DEPARTMENT OF TRANSPORTATION

MEMORANDUM

SUBJECT: University Boulevard Corridor Plan
Public Hearing Draft – Department of Transportation Comments

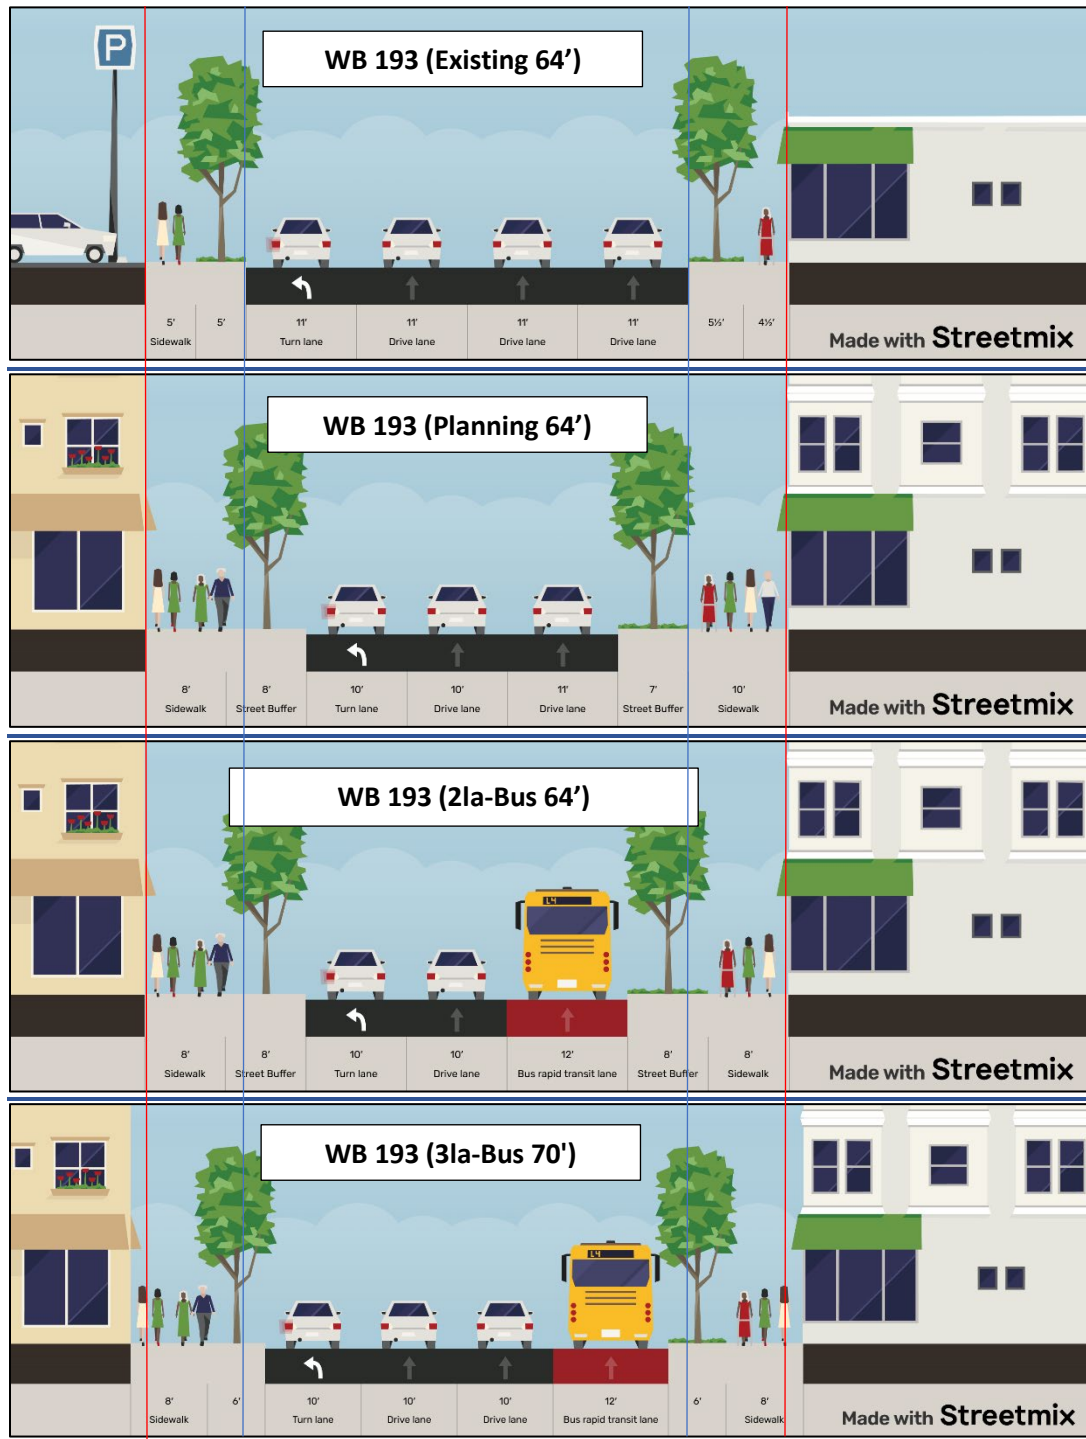
If necessary for additional space: consider potential bikeway options parallel to University Blvd which might accommodate Breezeway-level design parameters. One such option might use Timberwood Avenue, transitioning at the west through North Four Corners Local Park, and at the east via Pierce Dr / Lexington Dr. (shown in **blue** in the graphic below)

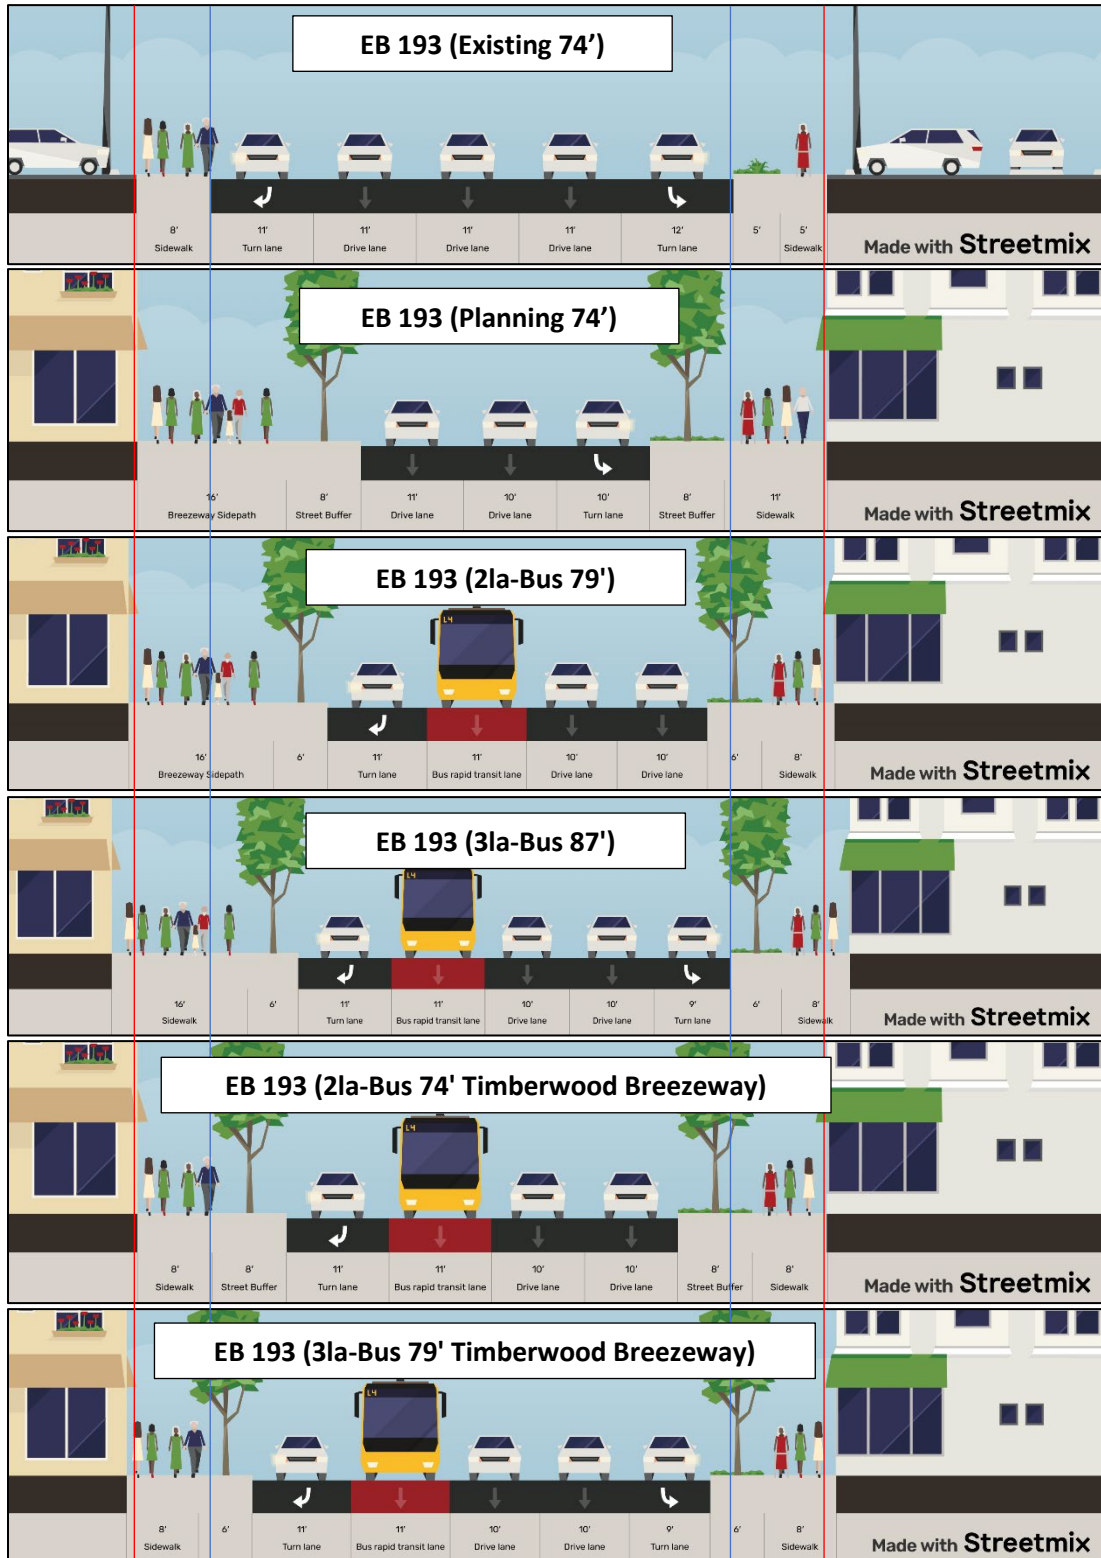
The cross-sections on the next two pages offer some potential options. In the westbound direction, our preference is for an additional bus lane necessitating +3’ on each side of the rights-of-way. In the eastbound direction, our preference is for an additional bus lane and a dedicated right-turn lane (as to remove right-turns from the bus lane), necessitating +6.5’ on each side of the rights-of-way.

Additional width beyond the existing rights-of-way can come from easements rather than dedication. While we appreciate the interest to keep the visual nature of the corridor narrowed as much as possible, we do not believe that the additional widths compromise this interest in our efforts to achieve other plan goals.
